Memo To: Samantha Yeung, Planner II
Memo From: James Pavlidis, Urban Designer
Subject: Zoning By-Law Amendment, Draft Plan of Subdivision
Applicant Name: Brutto Planning Consultant Ltd
Municipal Address: 13049 Bathurst Street
City File No.: ZBLA-24-0008, SUB-24-0002

Proposal Summary:

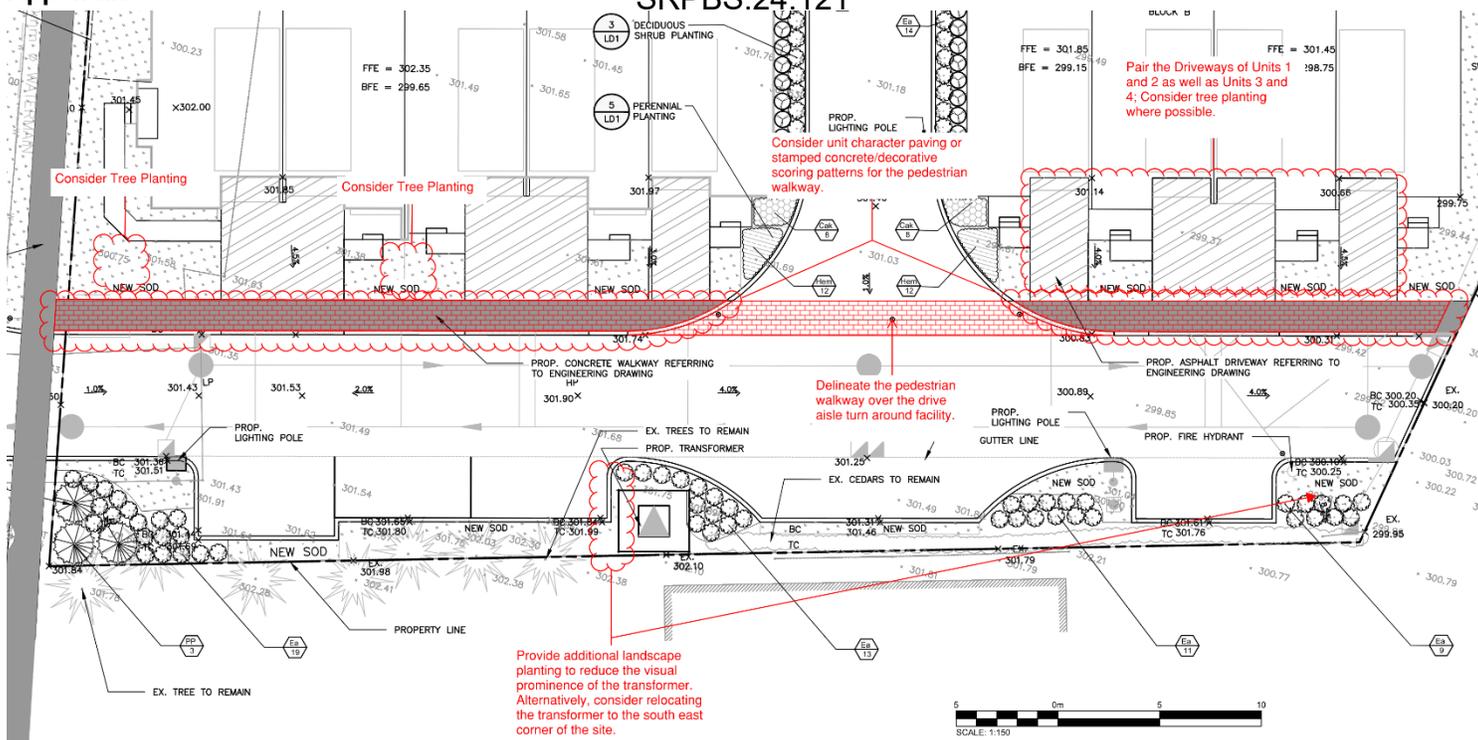
Provide additional landscape screening adjacent the transformer to reduce its visual impact along the public realm or relocate this unsightly element to the southeast corner of the site; consider tree planting where feasible; and, consider decorative paving for the pedestrian walkway, delineating this pedestrian connection across the drive aisle / turn around facility.
